Planning Commission

Planning Commission Meeting Agenda Hartland Township Hall Thursday, November 21, 2024 7:00 PM

Hartland Township Planning Commission Meeting Agenda Memorandum

Subject: Site Plan with Special Land Use Application #24-008 (Automobile wash at 10587)

NORTH ELEVATION SOUTH ELEVATION

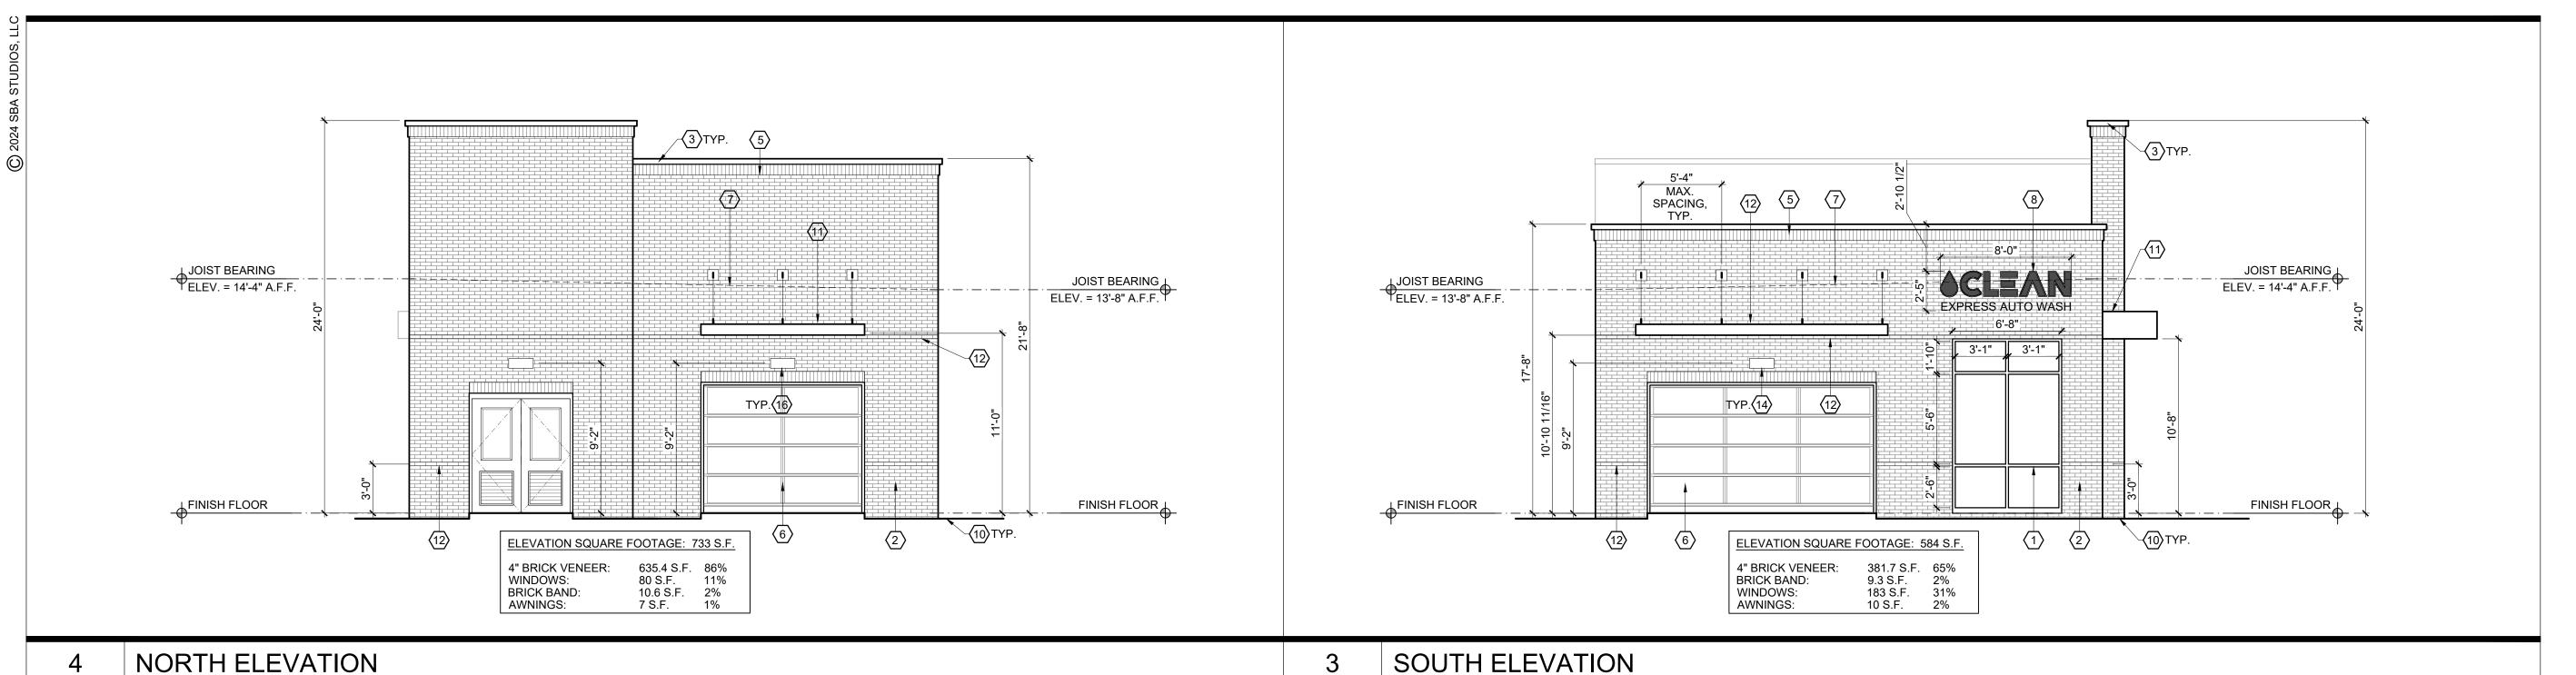
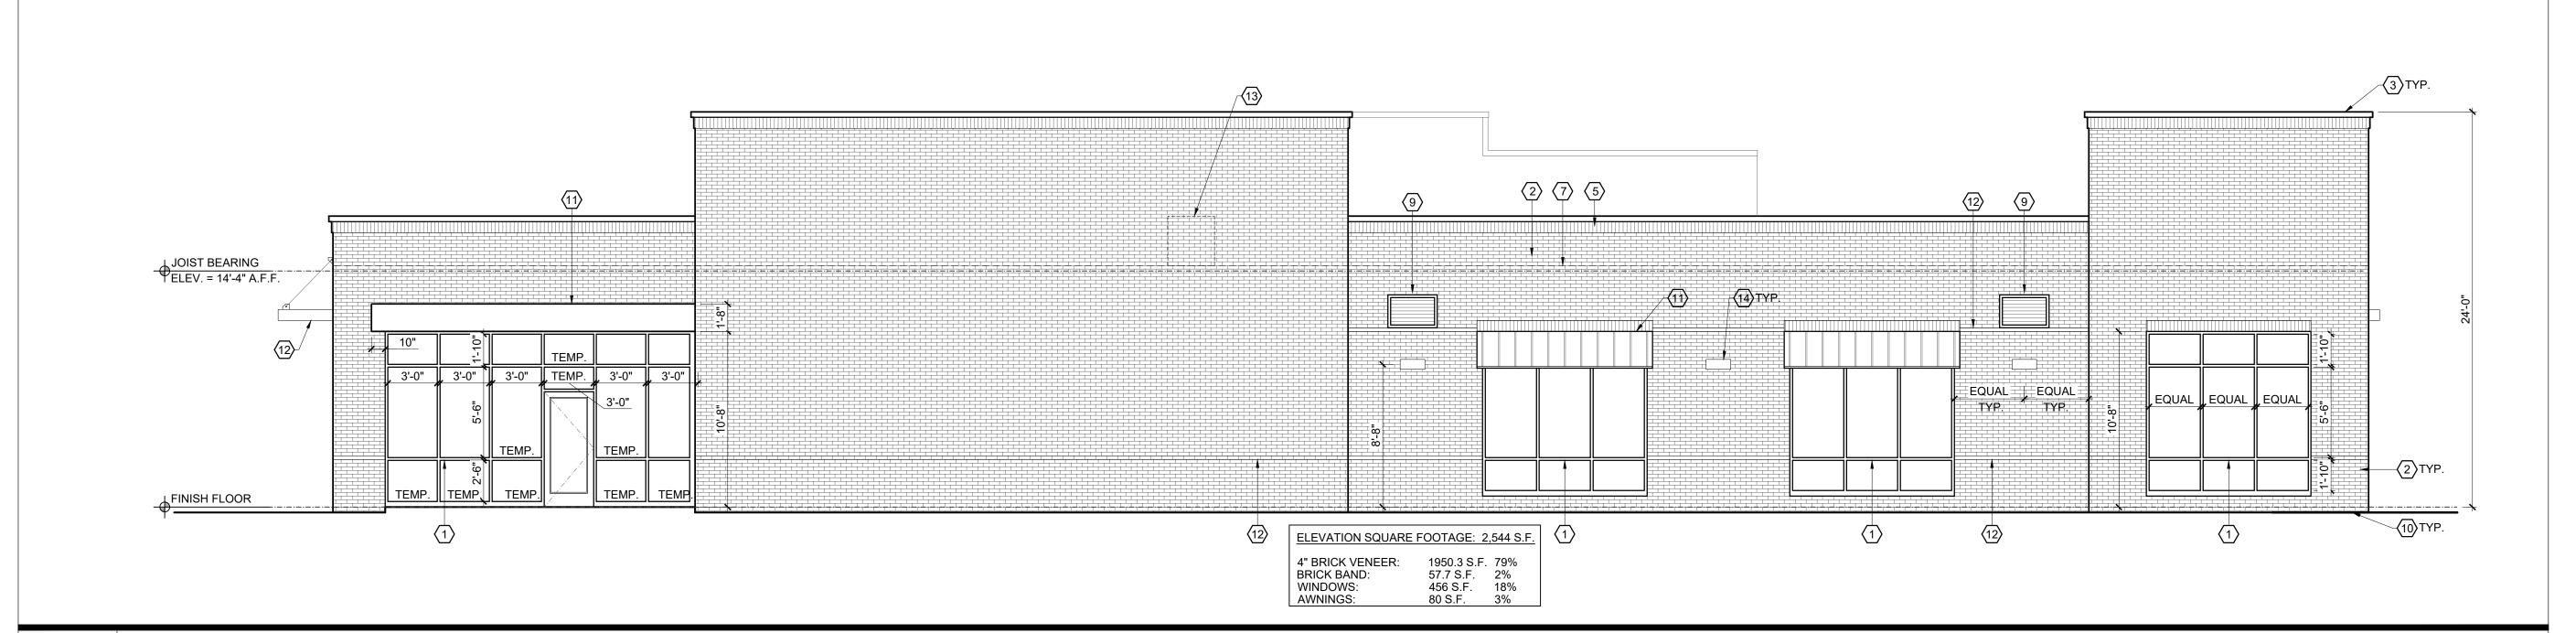
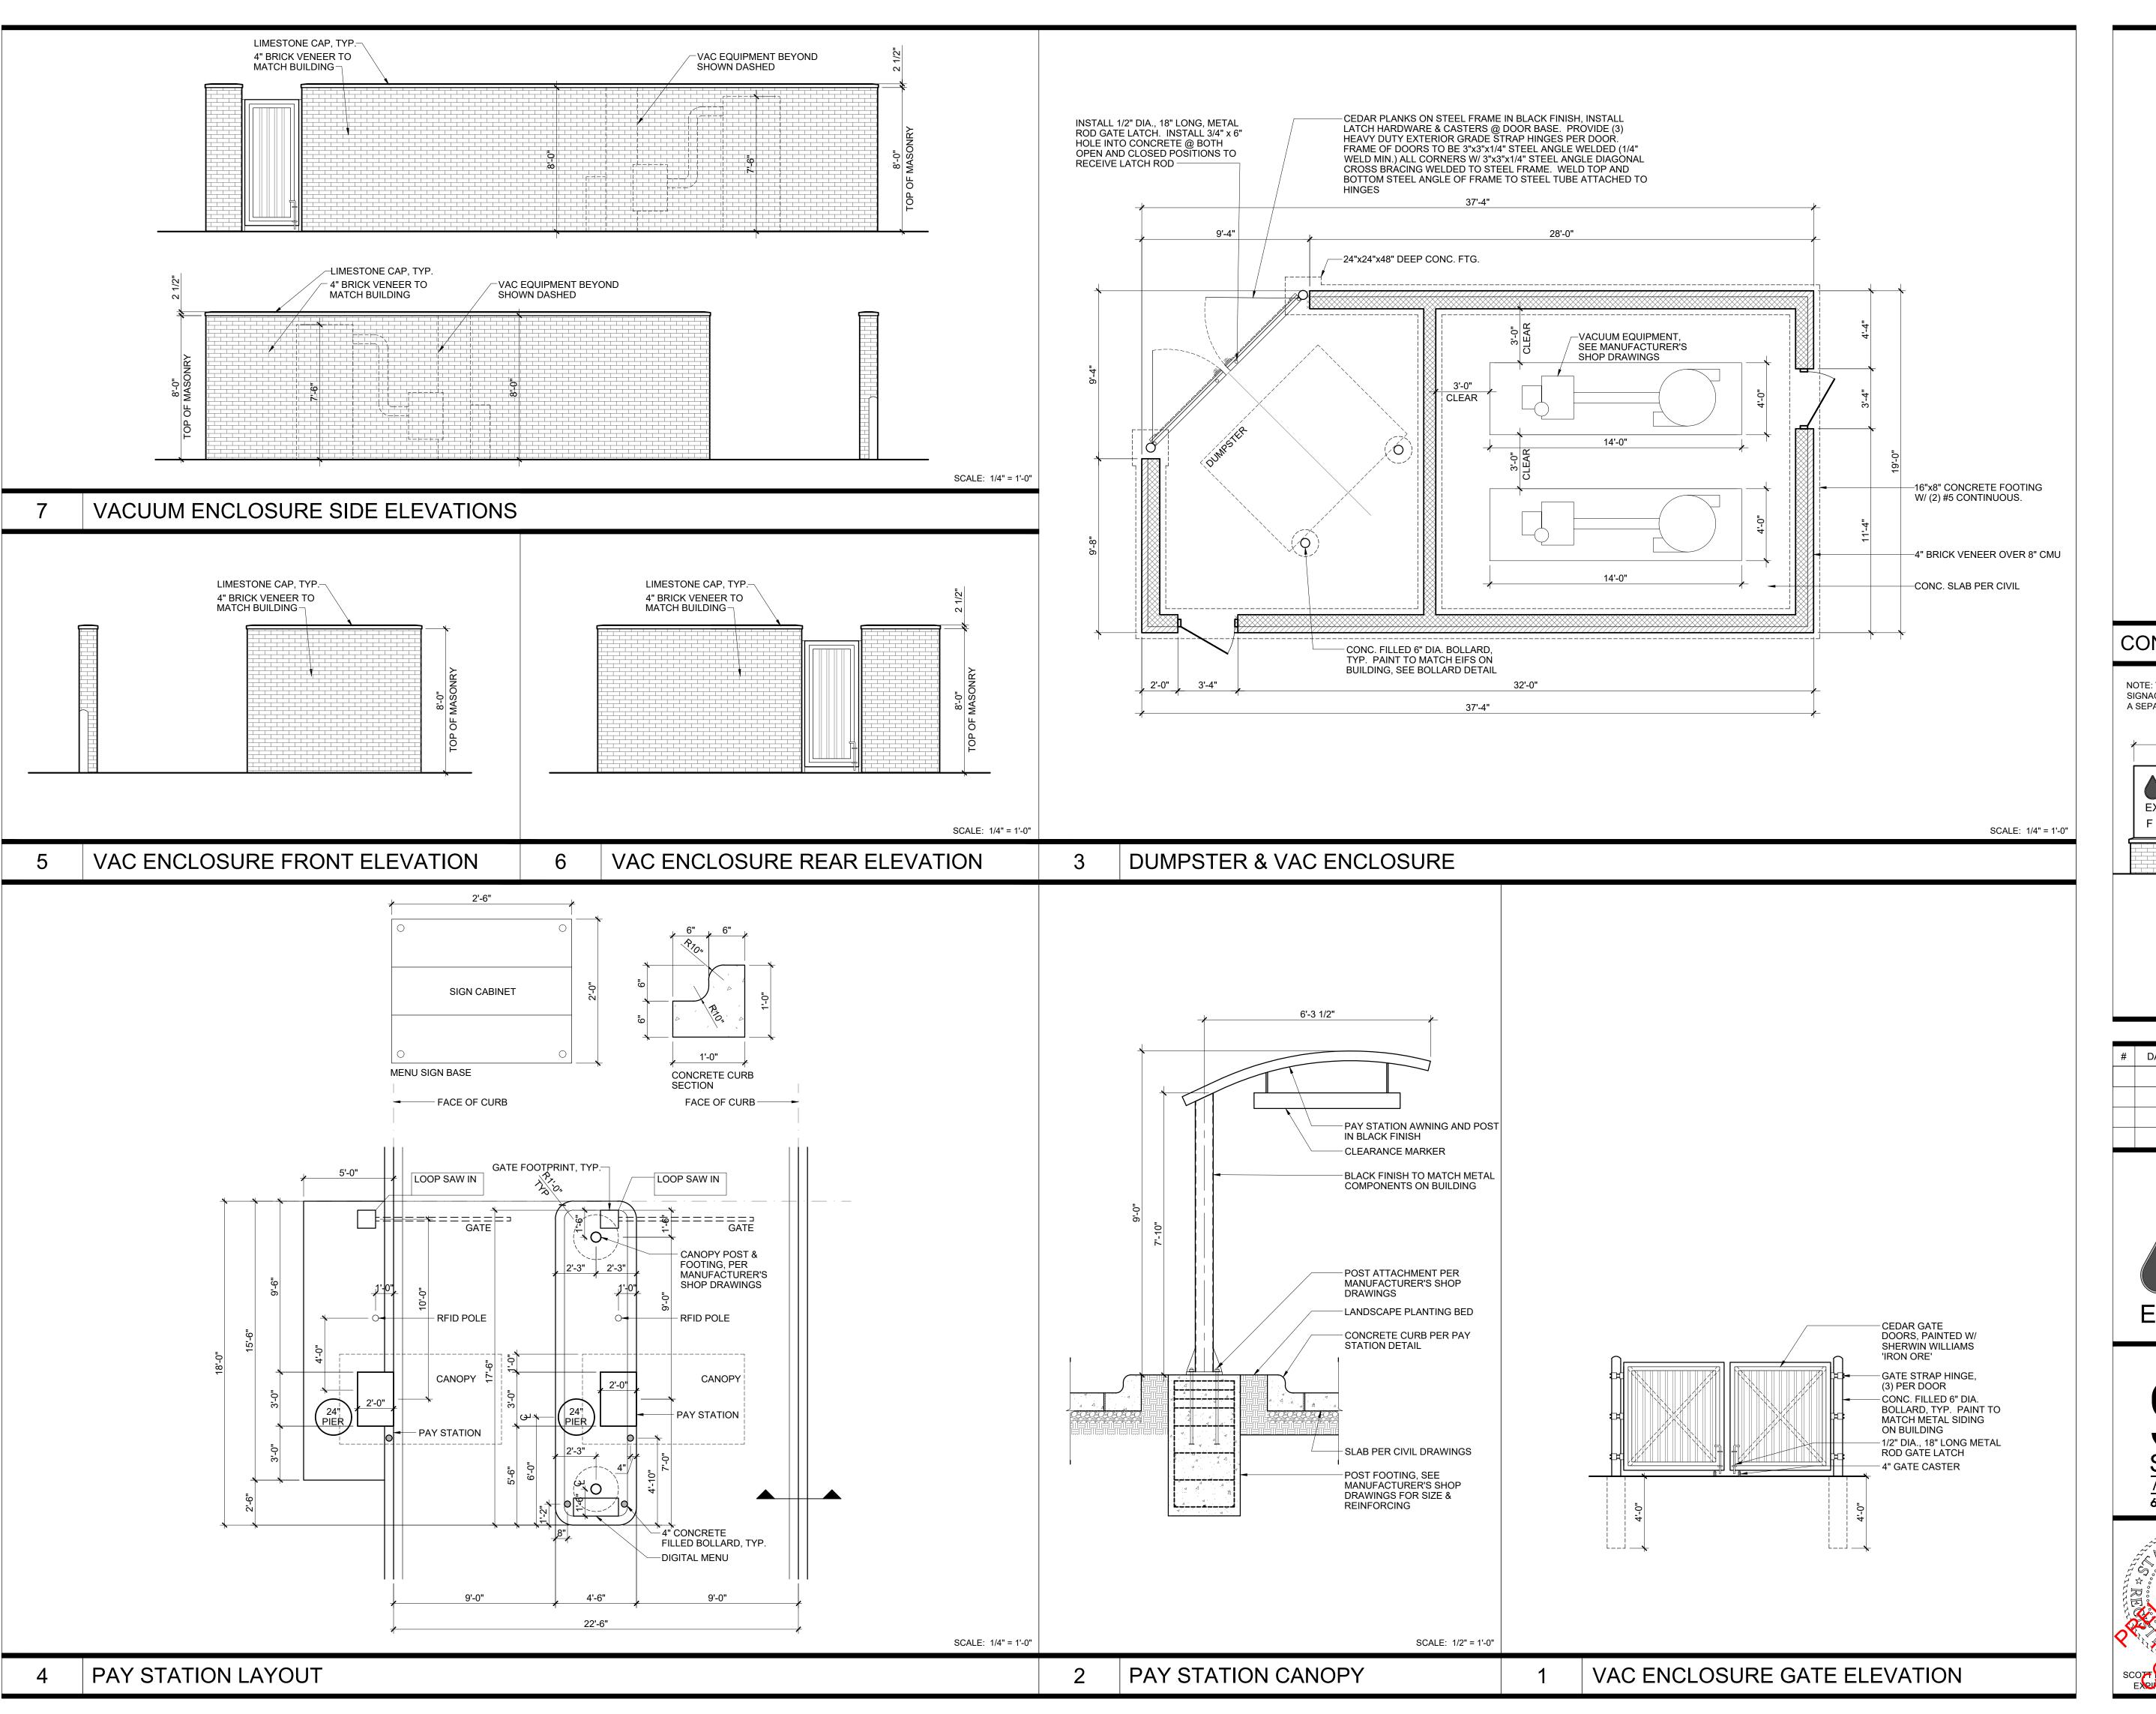
- All exterior light fixtures must be shown on the photometric plan wall mounted fixtures/wall packs (as shown on the architectural elevations, Sheet A2-1), decorative wall mounted fixtures, lighting under awnings/canopies, lighting for the flagpole, etc. Please review Section 5.13 (Lighting) in the Zoning Ordinance.
 All lighting fixtures are now shown on the lighting plan.
- 2. Lighting intensity must be measured at five (5) feet above grade. Please state the height at which the footcandle values were taken. If not taken at 5 feet, please revise the photometric plan, and include all exterior light fixtures (and associated footcandle values) as noted above. Footcandle values are shown on the lighting plan.
- 3. Provide a specification sheet for each exterior light fixture and state the manufacturer, model number, color, etc. Please add that to the light fixture schedule on Sheet C600.
